**Comment Response Matrix**  
**for**  
**Nuclear Regulatory Commission RAI-2009-02**  
**Second Request for Additional Information (RAI) on the**  
**Saltstone Disposal Facility Performance Assessment**  
**(SRR-CWDA-2009-00017, Revision 0, dated October 29, 2009)**

**April 2011**

Prepared by: Savannah River Remediation LLC  
Closure & Waste Disposal Authority  
Aiken, SC 29808

This document represents the first of two packages of responses to the comments transmitted via the *Second Request for Additional Information for the 2009 Performance Assessment for the Saltstone Disposal Facility at the Savannah River Site*, dated December 15, 2010. [ML103400571]

**Figure 1: Tc-99 release over the 10,000-year compliance period based on results  
(a) WSRC-STI-2007-00056 and (b) the 2009 PA model results**

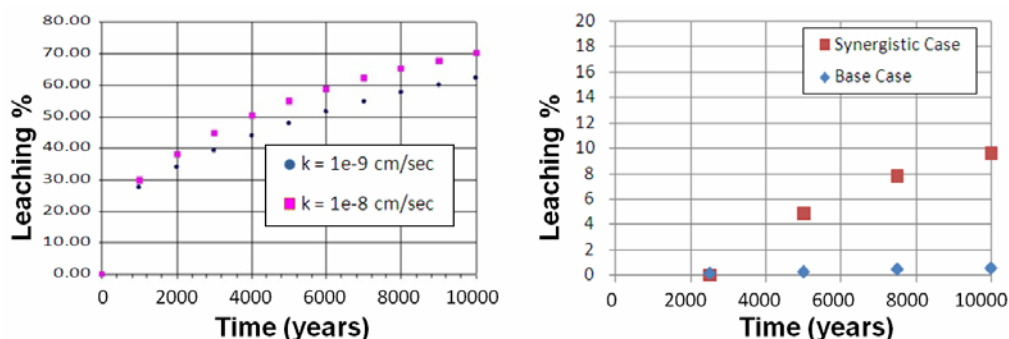
As discussed in WSRC-STI-2007-00056, experiments on Tc-99 leaching from saltstone simulated grout were conducted and the results incorporated into PORFLOW modeling. Figure 1 shows the modeled release of Tc-99 according to WSRC-STI-2007-00056 and the 2009 Saltstone PA. The modeled Tc-99 release for WSRC-STI-2007-00056 is approximately 60% over the 10,000-year compliance period for saltstone with a hydraulic conductivity of  $1\text{E-}9$  cm/s, which is slightly less than the assumed hydraulic conductivity in the 2009 PA of  $2\text{E-}9$  cm/s. According to the PORFLOW model files in the 2009 PA, the predicted release of Tc-99 from the saltstone material is 0.6% for the base case and 9.6% for the synergistic case.

The research presented in WSRC-STI-2007-00056 demonstrated the release of Tc-99 due to the presence of residual oxygen for an intact saltstone monolith. Residual oxygen would be consistent with field conditions at the SDF as would the transport of gas and liquid-phase oxygen to the fractured vaults and saltstone. In addition, the saltstone grout has been shown to be fractured which would increase the surface area-to-volume ratio, thereby increasing the oxidation of saltstone.

NRC staff recognizes that research is ongoing and that the results presented in Figure 1 below are based on a modeled system. However, this model is parameterized from experimental results conducted with a saltstone simulant whereas the shrinking core model utilized in the PA is less empirical. Additionally, some key parameters of the shrinking core model, such as the Tc  $K_d$  are based on a formulation that is drastically different than saltstone (see SP-15).

<p><b><u>Path Forward</u></b></p> <p>The PA should be consistent with relevant research or justification should be provided discussing why it was excluded. Provide any additional references on Tc-99 leaching from saltstone that have not already been provided to the NRC.</p>
<p><b><u>RESPONSE SP-19:</u></b></p> <p>Response will be provided in SRR-CWDA-2011-00044, Revision 1.</p>
